GROUP	MODEL
Safety Recall Campaign	2015-2018MY K900 (KH)
NUMBER	DATE
SC284KH	April 2024

SAFETY RECALL CAMPAIGN

HECU FUSE REPLACEMENT (SC284KH)

This bulletin provides information to replace the fuses of the Hydraulic Electronic Control Unit (HECU) and install an updated junction box label on certain 2015-2018MY K900 (KH) vehicles produced from December 18, 2013 through October 30, 2017. An engine compartment fire may occur in the area where the HECU is located. The HECU may experience an internal electrical short circuit condition that can result in overcurrent, thereby increasing the risk of an engine compartment fire while the vehicle is driven or while parked. Dealers are to install new fuses to prevent an electrical short circuit condition in the HECU's electrical circuit board. Customers may experience illumination of the Malfunction Indicator Lamp (MIL), ABS warning light, burning/melting smell, and/or smoke from the engine compartment. Follow the procedure outlined in this publication to install new fuse(s) and junction box cover label(s) on the applicable vehicle. Before conducting the procedure, verify that the vehicle is included in the list of affected VINs.

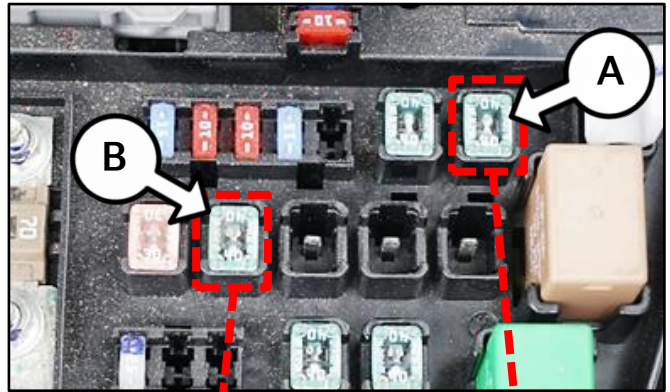
1. Open the hood.
2. Remove the junction box fuse cover.

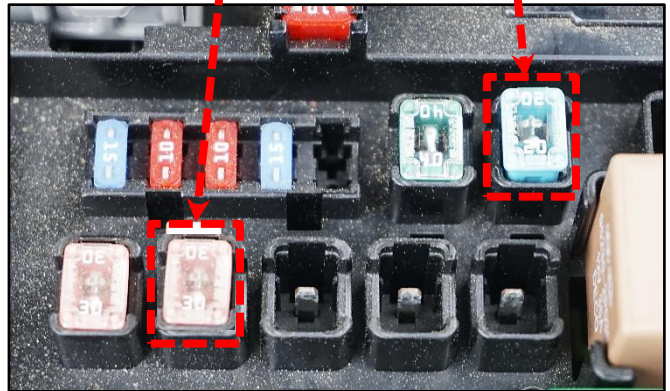
- 3a. Remove both existing HECU ESC1 40A (A) and ESC2 40A (B) fuses.

- 3b. Install new amperage fuses:

- ESC1 fuse (A) → new 20A
- ESC2 fuse (B) → new 30A

Ensure to replace ESC1 fuse (A) with the 20A fuse and ESC2 fuse (B) with 30A fuse.

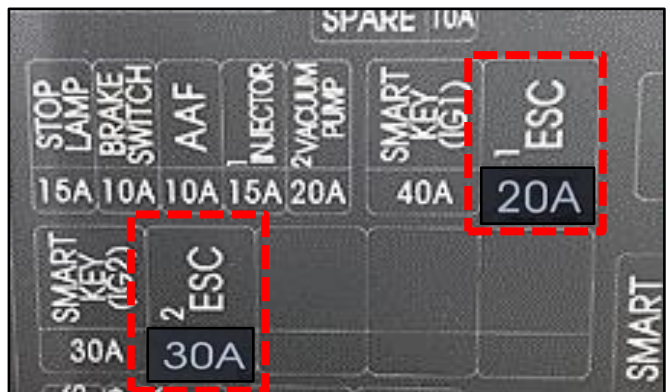
4. Adhere the new ESC1 20A and ESC2 30A labels to the bottom of the junction box fuse cover, as shown.
